**STAFF REPORT:** APRIL 9, 2025 MEETING  
**APPLICATION NUMBER:** HDC2025-00054  
**VIOLATION NUMBER:** 25-981  
**ADDRESS:** 1760 WABASH

**SCOPE:** INSTALL LAP SIDING (WORK COMPLETED WITHOUT APPROVAL), ADD DETAILS TO HISTORIC AND NEW GABLE WALLS, INSTALL WINDOW AND RESIZE EXISTING WINDOWS ON FAÇADE, REBUILD WINDOW CASINGS-ALL SIDES, REMOVE SIDING FROM CHIMNEY

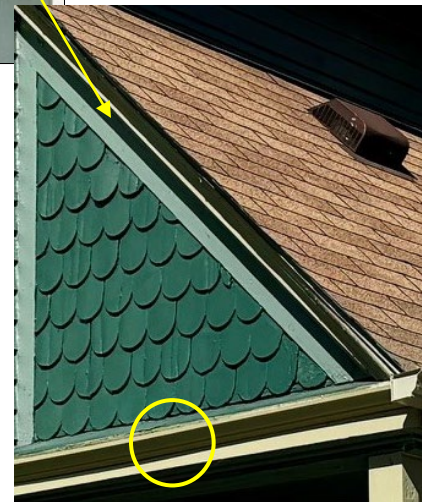
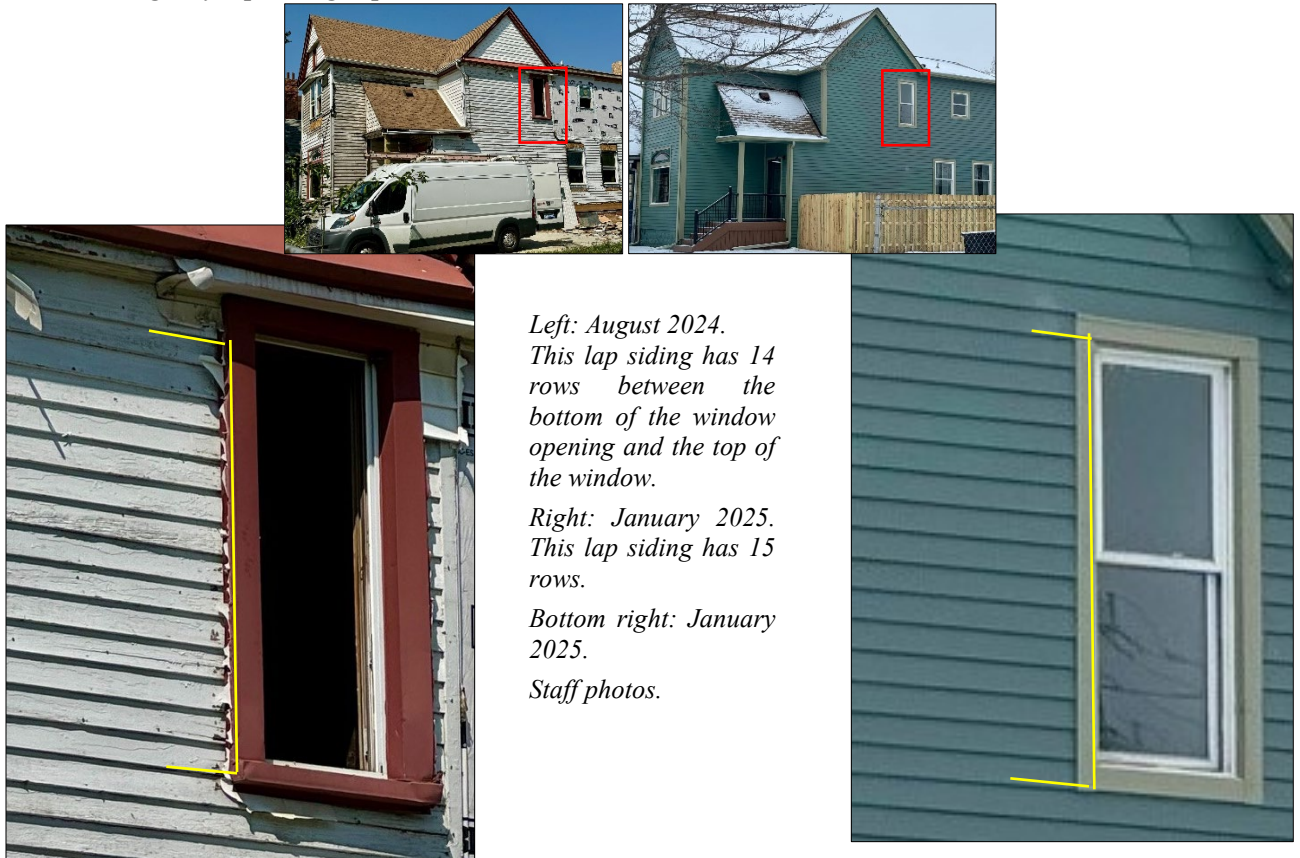
August 2024. This photo shows that the historic scallop siding had a similar smooth surface texture as the adjacent historic lap siding. The scallop siding is uniformly framed with flat trim, and then two outer sections had thickly dimensioned bargeboard trim applied to meet the roof/porch ceiling. Staff photo.

January 6, 2025. The reflective sheen of the paint shows the smooth surface of the historic scallop panels (where cracks aren't present). Note the highly profiled bargeboard at the angled roof remains, similar to the historic condition (at left), but it appears as though the lower wide bargeboard has been replaced with a narrower product. Staff photo.

March 26, 2025. While preparing this report staff identified that the historic bargeboard at the roof edge has also been replaced with a thinner, less profiled product. Staff photo.

Dimension – height of lap siding exposure

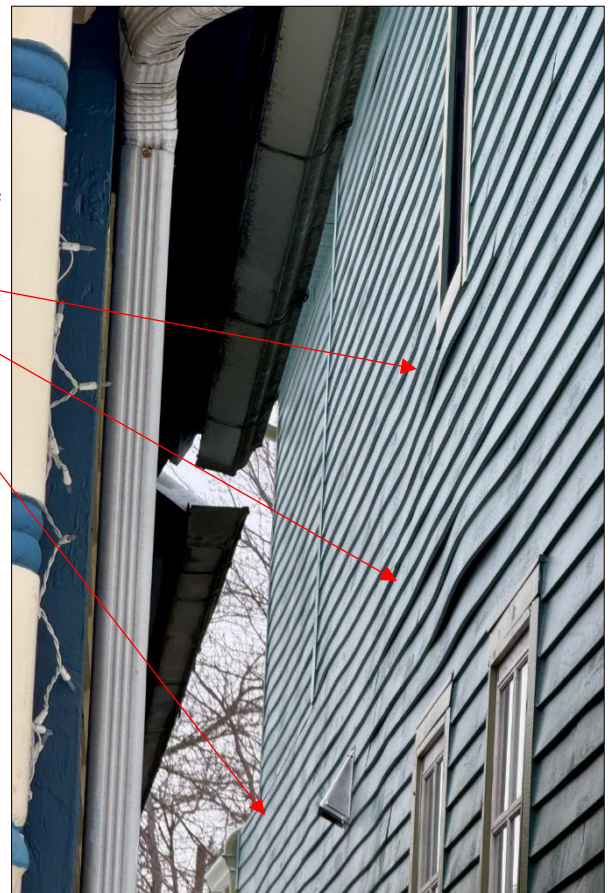
- Comparing the same window “before and after” staff counts a different number of rows of siding, going from 14 to 15.
- Another concern with the installed lap siding are the multiple gaps on the north side wall, and general waviness.

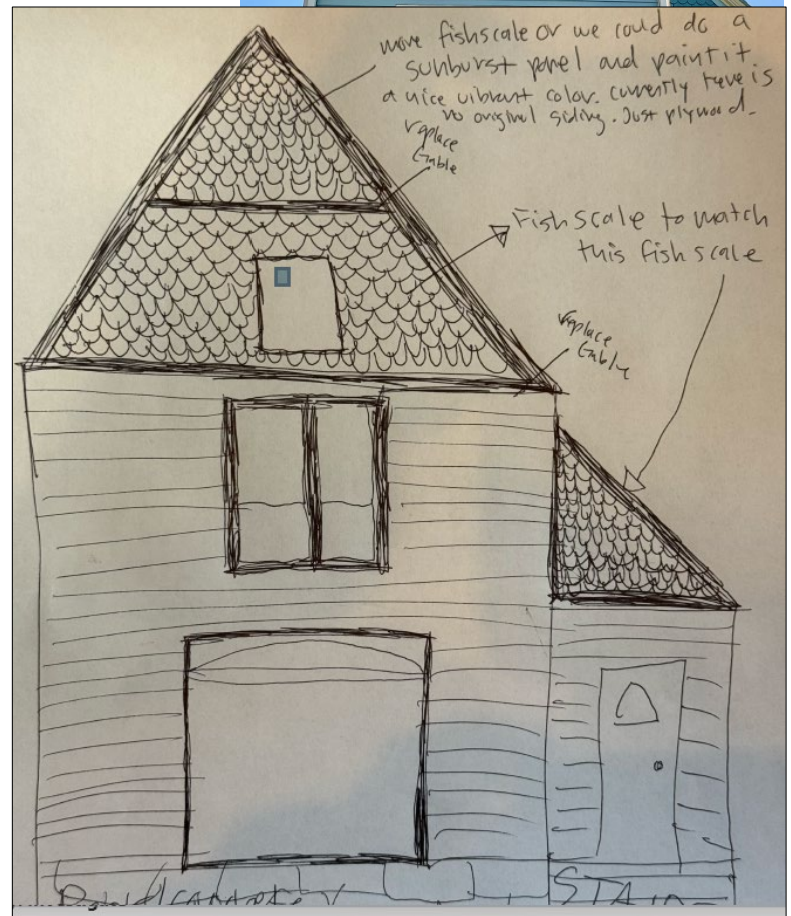
*This view shows the dimensionality of the closed pediment gable. The top portion of the wall extended forward, and an overhanging element protruded even more. The window was removed, as was the aluminum-covered bargeboard and pent roof (this angle shows the underside of the pent roof).*

*All of the removed elements were distinctive character-defining features.*

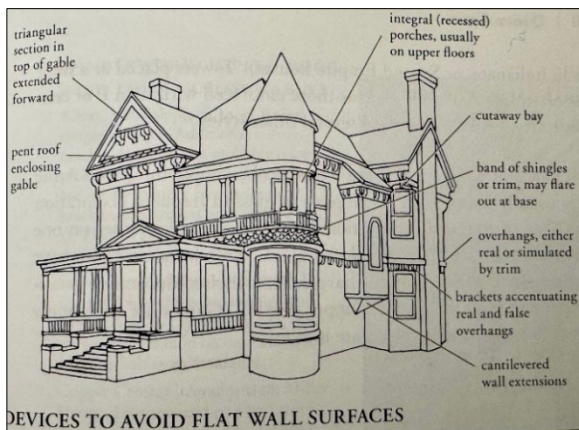
*Applicant sketch. As there is no documentation of the gable's wood siding upon removal of the vinyl siding. It is staff's opinion the elements offered in the sketch are compatible with the era and design of this Queen Anne house, with the additional expression (not called out here) of the upper gable wall extending forward of the gable's lower wall. Dimensions of each element and physical samples will be required for staff review and approval prior to any work taking place.*

- The front gable sketch included with this application is not sufficiently detailed for construction purposes. Dimensioned drawings and wall sections should be created for the front and side gables, noting all elements within each gable and specifications for painting (color(s) and sheen) will be included on the drawings and submitted to staff for review before any work takes place.
- Upon removal of the siding from the chimney, no masonry work, outside of tuckpointing (if needed) will occur without submitting to staff for review and approval - a scope of work, visual and physical documentation of existing conditions which show why the existing brick is beyond repair, and a physical sample of replacement brick.

**Gable at south-side wall – alteration and applicant proposal**

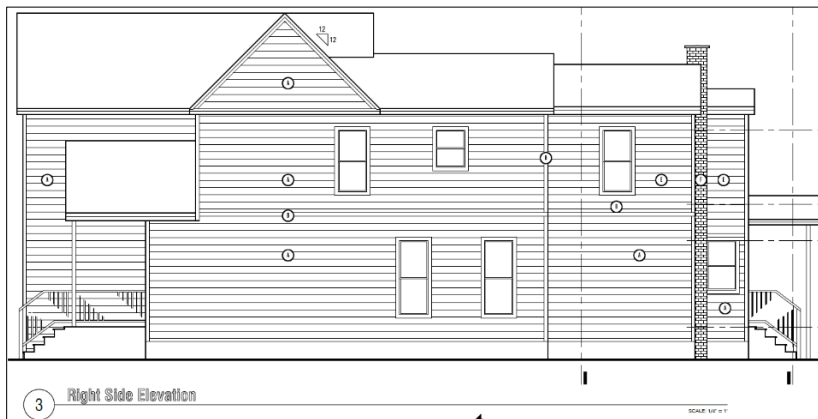
*Approved drawing shows the closed pediment.*

- An elevation drawing and wall section confirming the decorative details at this gable will need to be submitted to staff for review. It is staff's opinion that lap siding, rather than fish scale siding, can be appropriate for the gable wall at this secondary location.

February 21, 2024      Staff photos.      January 9, 2025  
 Approved drawing of front wall, changes at right were made without HDC approval.

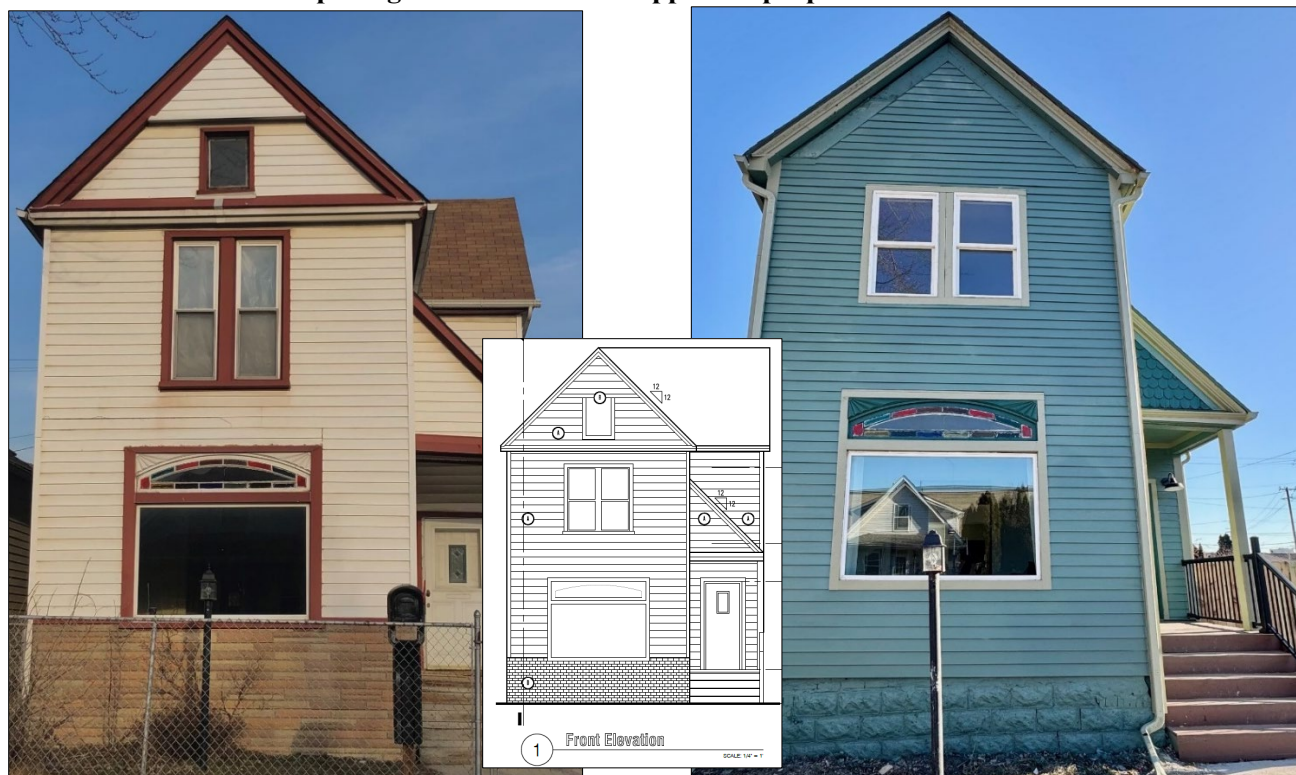
- The window within the gable was lost, and dimensional changes were made to the second floor windows – they are shorter in height and wider in width, the dimensional mullion was removed, they are placed forward in line with the window trim (rather than recessed like the previous replacement windows), and dimensional window casing/trim was removed and replaced with flat trim.
- A common feature on 19<sup>th</sup> century houses are tall, narrow double-hung windows. Multiple windows were joined by structural wide, flat mullions. Additional distinctive features that clearly identify dwellings of 19<sup>th</sup> century construction are the window casings: butt joints, a header with a small overhang at the top, equal-sized side trim, and a narrower, protruding sill. The February 2024 photo shows the protruding sill was still in place, covered with aluminum.

- A dimensioned drawing of the proposed window casings, to serve as a prototype for each opening, is required for staff review, and solid wood (no composite product) will be used.
- The second story double window will be resized to match the dimensions of the original opening. A dimensioned drawing will be submitted for staff review and will confirm the recessed placement of the windows and an installation of a wood mullion, matching the one that was removed. The window order for the two double-unit windows will be submitted for staff review.

**E-SERIES DOUBLE-HUNG WINDOW**

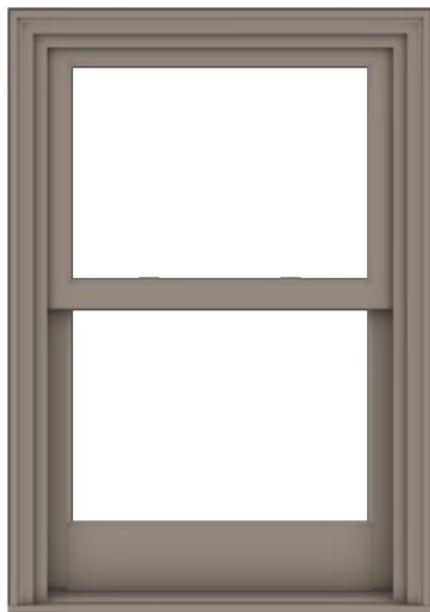
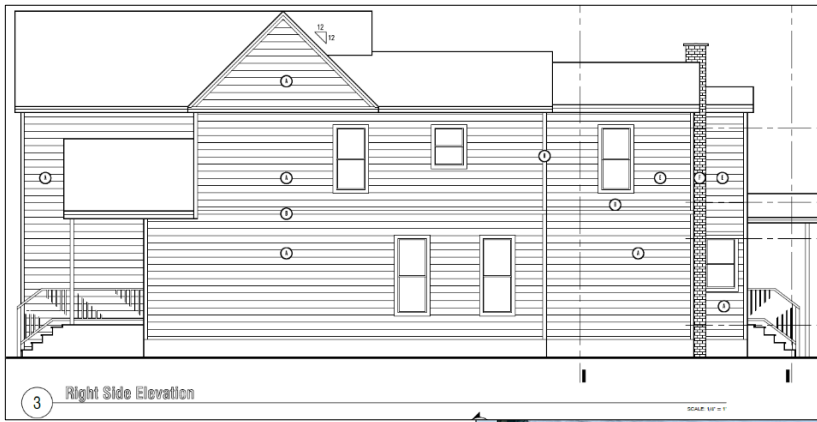
*Left: Anderson E-series double-hung window. Staff used the sandtone color from Anderson's website for this comparison, as the width and profile of the framing is clearly visible.*

*Right: Existing replacement window in one of the new windows openings on the rear wall.*

*The dimensions and depth of framing of the Anderson window is more compatible with the dimensions and profile of a historic wood window.*

*Above: Approved drawing for south-side wall. During BSEED ePlans permit review, staff approved one additional window opening at the first floor rear, under staff authority for minor revisions to an HDC approval.*

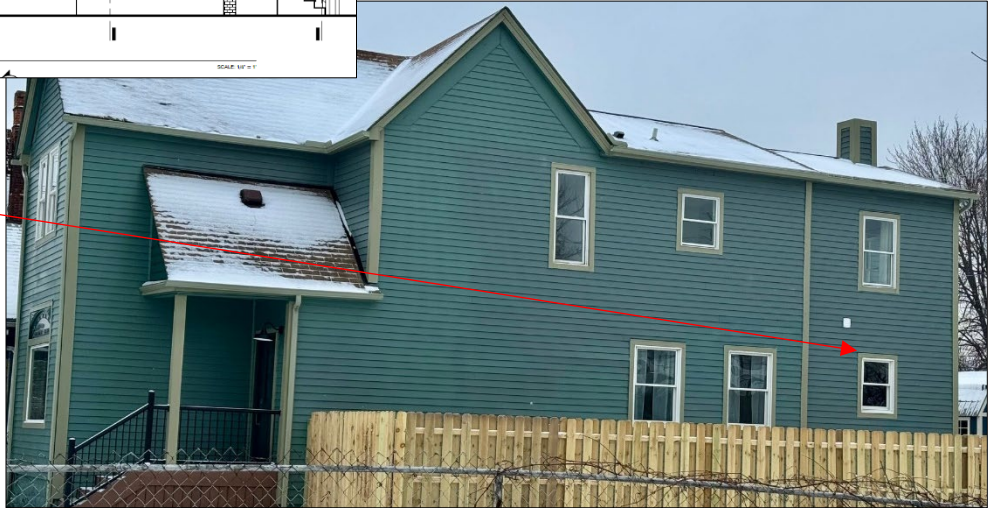
- As first identified on page nine, while reviewing photos for this staff report, staff noticed that at least one window opening doesn't fully fit the cut opening on the south-side wall.

*Approved drawing and undated photo.*

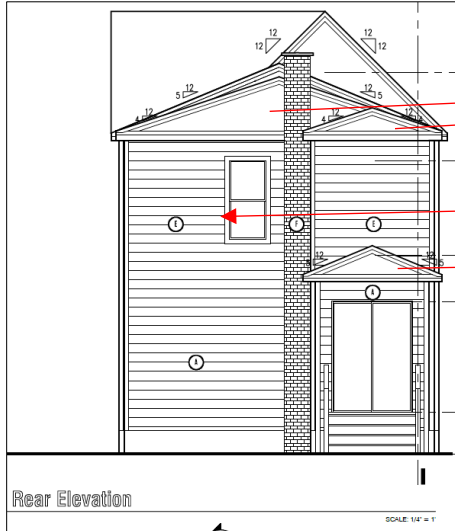
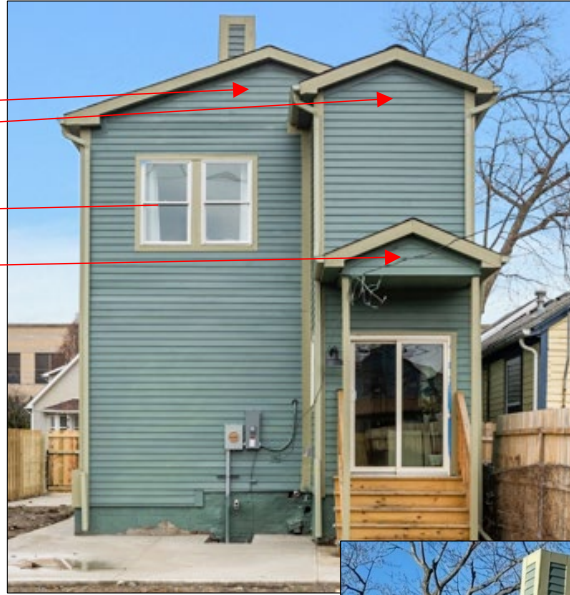
- Changes made to the approved project at the rear wall include:
  - One additional window at the second floor.
  - No closed gables.
  - The historic chimney clad in siding.

- Raised height of the rear porch roof.
  - New chimney not erected.
- It is staff's opinion that the location of the additional window opening is appropriate, however the window itself, its placement within the opening, and lack of mullion and dimensional trim, is not.

- The gables for the rear-facing walls and covered porch were erected with a different design than originally proposed, and the applicant submitted a drawing to show how the gables could be enclosed. These walls and gables are of different proportions (including roof pitch) than the historic gables and all relate to each other on the rear wall, so staff believes the open design and flat rakeboard are compatible for new construction and this rear-facing location.

- The cladding of the chimney is not compatible with the age and architectural design of the house, and staff agrees with the applicant's proposal to remove the siding and expose the historic brick. The recladding of this feature without submitting visual and physical documentation that the existing brick and chimney is beyond repair, would not be approved/recommended by staff.

- It is not clear to staff why the gable roof over the rear entry door was erected so high, as it is out of proportion with the rear door. However, this small roof structure is not demonstrably inappropriate, is at the rear facing the alley, and can be removed in the future without any impact to the integrity of the historic structure.
